**SUBDIVISION, PLANNED UNIT DEVELOPMENT,
PLANNING APPROVAL, ZONING AMENDMENT,
& SIDEWALK WAIVER REQUEST
STAFF REPORT**

Whisper Oak Subdivision

Whisper Oak Mobile Home Park

4512 Higgins Road
(North side of Higgins Road, 215'± West
of Shipyard Road)

SITE PLAN

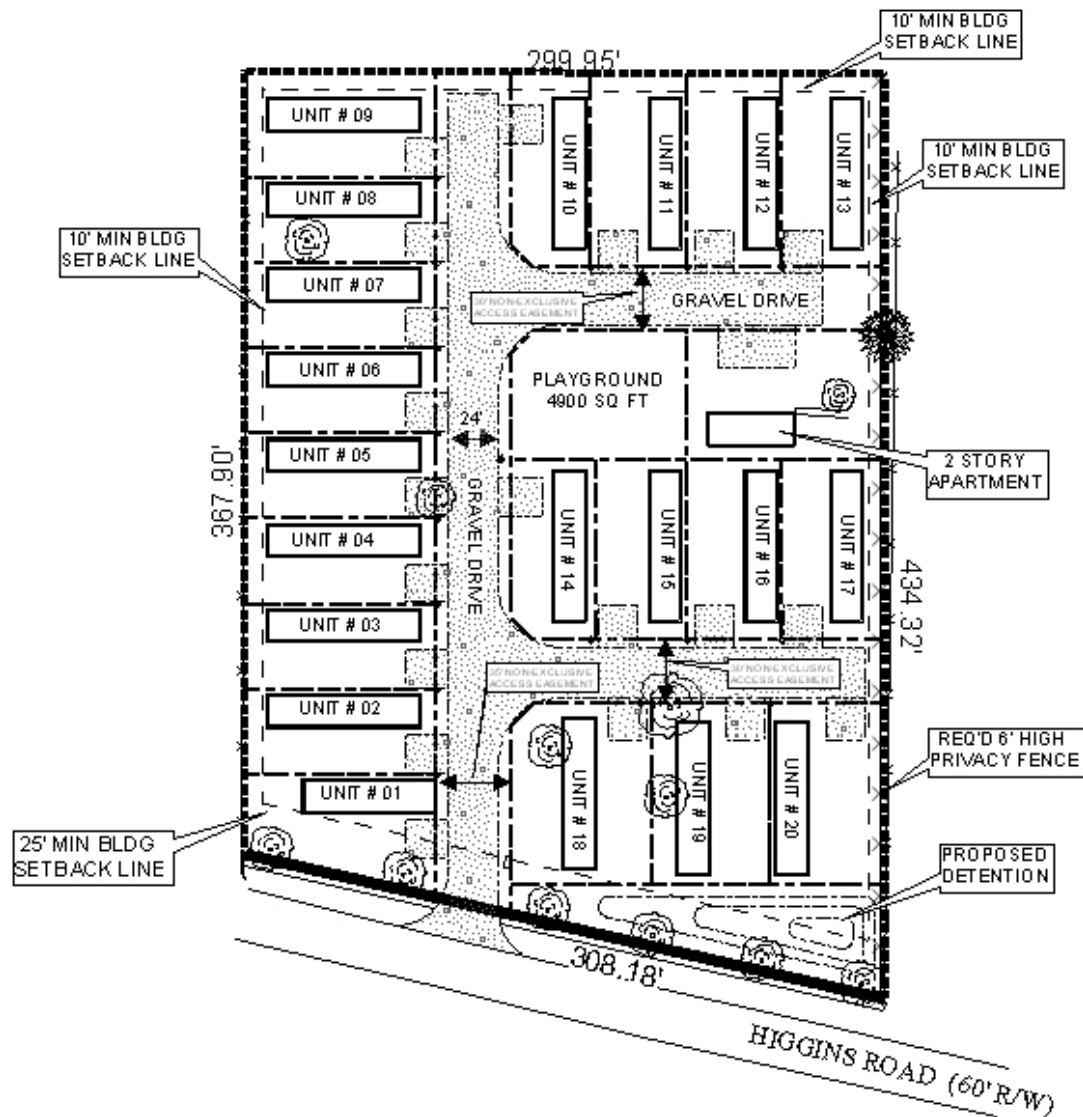
Regarding the lot layouts, Lots 1 and 21 appear to show the mobile home location area partially within the 25-foot minimum building setback line. No part of the mobile home location area should be located within the building setback. Also, regarding the size of each mobile home lot, Section 37-53 of the Mobile City Code requires a minimum lot size of 3,200 square feet for each mobile home lot. Area sizes for the lots are not shown, however, it appears that some lots may not meet this requirement. As such, each lot's size should be depicted to ensure that each meets the minimum size requirement.

Regarding access, the site plan depicts access as being via 20-foot wide gravel drives. The minimum size for two way accessways is 24 feet in width, and all accessways must be paved with asphalt or concrete. Additionally, parking of a sufficient number is depicted, however, the parking is depicted as being gravel; this should be revised to show the parking as asphalt or concrete.

The site plan is depicting an 8-foot setback to the East. The property to the East is developed as and zoned Single-Family Residential. As such, a 10-foot setback would be required to comply with buffering requirements. Additionally, no buffer is depicted, and, at a minimum, a privacy fence compliant with Section 64-4.D.1. should be provided.

It should be noted that Chapter 37 of the Mobile City Code sets out several design requirements for mobile home parks, and, as this application proposes substantial changes to the site, the provisions of Chapter 37 apply. Specifically, the site plan needs to show the following:

- Section 37-56: a playground common area surrounded by a fence or a wall of at least 4 feet in height containing 150 square feet for each mobile home lot
- Section 37-57: a dedicated patio area of at least 180 square feet on each lot, surfaced with rigid impervious pavement

The site plan does not indicate compliance with the tree and landscaping requirements of the zoning ordinance. Full compliance should be required.

The revised site plan indicates that all of the mobile home sites have been modified to remove all building sites from the setback areas, and the accessways have been increased to 24 feet in width. The applicant has, additionally, removed two of the mobile home lots to be able to maintain the required size of the lot (3,200 square feet), and the applicant has also indicated the common space/playground area as required in Section 37-56 of the Mobile City Code. The site plan also now indicates the required buffer located on the east side of the property, and the landscaping plan also appears to comply with the requirements of the Zoning Ordinance.

The site plan does not indicate the dedicated patio area of at least 180 square feet on each lot, surfaced with rigid impervious pavement as required by Section 37-57 of the Mobile City Code. Chapter 37 gives the Planning Commission the authority to waive this section of the Chapter, and the applicant has requested such a waiver. The applicant states that they wish to construct elevated wooden patio decks “because it would provide better use to the elevated mobile homes.” This modification seems reasonable, however, the decks should be shown on the site plan and a stipulation be placed on the approval stating that the wooden decks must meet all applicable building codes and be maintained perpetually to ensure safety.

The applicant is also continuing to indicate gravel driveways and parking areas. The applicant has submitted an application to the Board of Adjustment for the gravel surfacing, and, if the PUD is approved, it should be subject to Board of Adjustment approval with the stipulation that if it is not approved by the Board, then concrete or asphalt surfacing would be required.

- 1) revision of the site plan to remove all mobile home sites from the 25-foot minimum building setback line;
- 2) revision of the site plan to depict all two way accessways as being at least 24 feet in width;

- 3) revision of the site plan to depict all accessways and parking as either asphalt or concrete;
- 4) revision of the site plan, and redesign, as necessary, to depict all mobile lots as being at least 3,200 square feet in area;

- 5) revision of the site plan to depict the required playground/common area as required in Section 37-56 of the Mobile City Code;
- 6) revision of the site plan to depict the dedicated patio area as required in Section 37-57 of the Mobile City Code;

- 7) revision of the site plan to depict the 10-foot required setback and buffer area where the site abuts residentially zoned property as well as a privacy fence in compliance with Section 64-4.D.1. of the Zoning Ordinance; and

- 8) submittal of a landscape plan showing full compliance with the tree planting and landscaping area requirements of the Zoning Ordinance.

- 1) completion of the rezoning process;*
- 2) approval by the Board of Zoning Adjustment of the surfacing variance to allow gravel parking and driveways, if the variance is not approved, accessways and parking areas will be surfaced with concrete or asphalt;*
- 3) depiction of the wooden decks at each mobile home lot;*
- 4) placement of a note on the site plan stating that the wooden decks must meet all applicable building codes and be maintained perpetually;*
- 5) full compliance with tree planting and landscaping requirements;*
- 6) submittal of two copies of the revised site plan incorporating any changes to the Planning Section of Urban Development prior to the issuance of any permits; and*
- 7) full compliance with all municipal codes and ordinances.*
